PLANNING, ZONING, & BUILDING DEPARTMENT  
PZ&B Staff Combination Memorandum: Architectural Commission and Town Council

SUBJECT: ARC-24-0032 (ZON-24-0028) 272 VIA MARILA

MEETING: SEPTEMBER 25, 2024, ARCOM  
OCTOBER 9, 2024, TC

**ARC-24-0032 (ZON-24-0028) 272 VIA MARILA - COMBO.** The applicant, Melissa Wight, has filed an application requesting Architectural Commission review and approval for a new vehicular gate which requires one (1) variance to reduce the minimum driveway area in front of the vehicular gate. This is a combination project that shall also be reviewed by the Town Council as it pertains to zoning relief/approval.

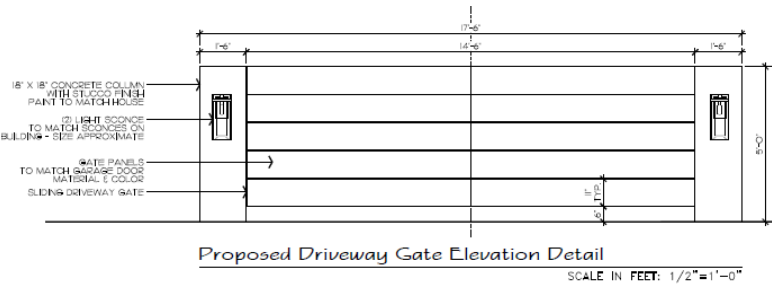
A preliminary review of the project indicates that the application, as proposed, is inconsistent with the Town zoning code and therefore requires a variance as part of this application. The subject site is an interior lot and currently contains one wide vehicular access driveway along its north property line on Via Marila. The subject property is 108' wide. Based on the surrounding area, the

introduction of the gate would also be inconsistent with all the residences that face Via Marila as there are no other vehicular gates.

**CURRENTLY PROPOSED VEHICULAR GATE**

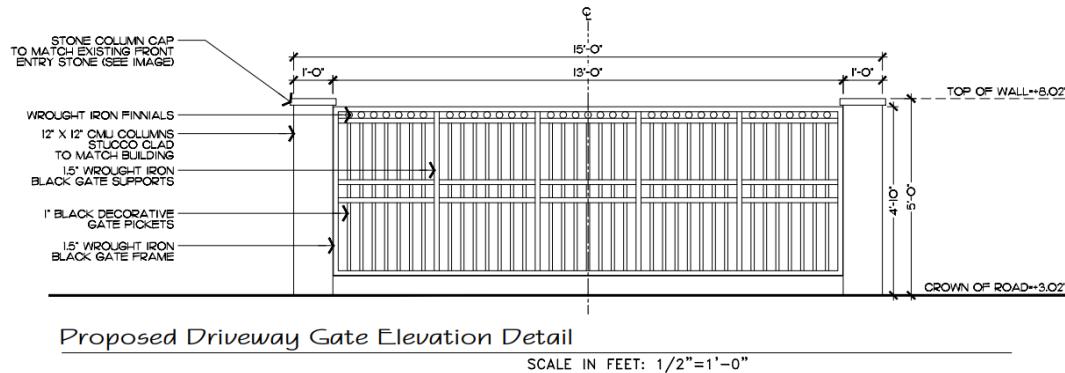
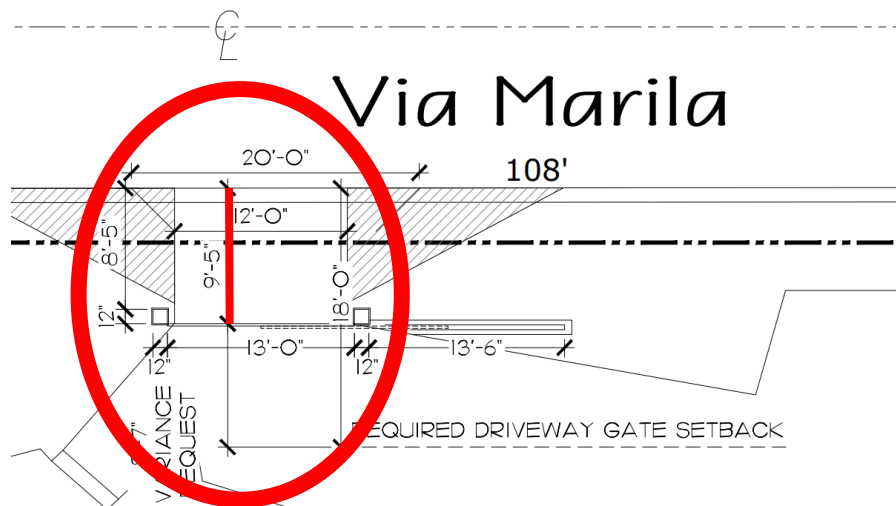
The current proposed decreased the driveway width by 2'-0" (from 14'-0" to 12'-0") and the gate width by 1'-6" (from 14'-6" to 13'-0"). The gate design was also revised to a black wrought iron gate with pickets and finials. This design offers greater transparency than the previous proposals.

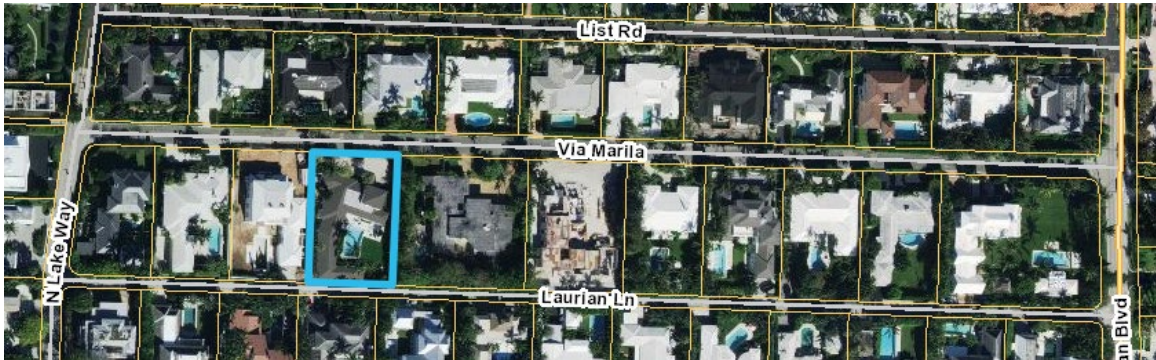
The proposed gate requires a variance as the required backup space is not being met, potentially creating an unsafe condition or blockage within the roadway. The applicant has provided 9'-5" of clearance where 18'-0" is needed. It is important to note that Via Marila is a very narrow roadway of only approximately 30'-0' wide.

Code Section	Required	Proposed	Variance
<b>Variance 1:</b> Section 134-1668	18'-0"	9'-5"	8'-7"
